Access Compliance Report Public Rights-of-Way (Curb Ramps)

Main Street: LEAFWOOD_LN		Cross Street: DALL_LN		Location:	SE
ADA ID: RPAT211019111455	Ramp Type:Type 1 - Perpendicular Diagonal Initial Pass/Fail: Fail		Overall Compliance: No	Severity Score:	15
Codes/Mitigation Info/Possible Solution			Field Measurements/Component Compliance

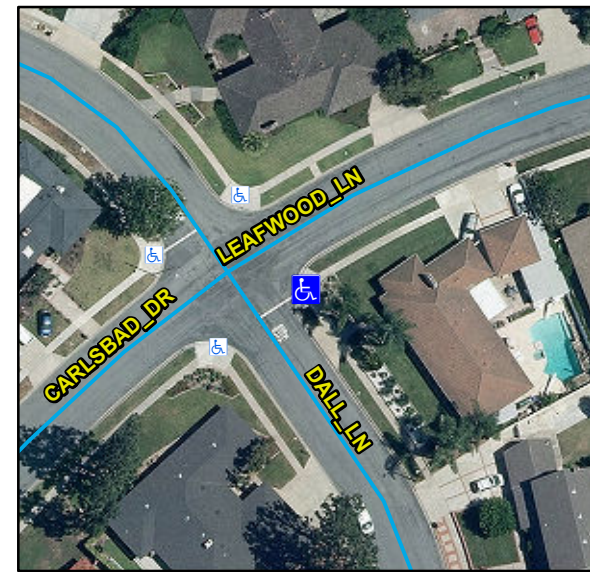
Remove & Replace Curb Ramp With Two New Directional Ramps or Equivalent.

R204.3, R304.2.2, STD 1115
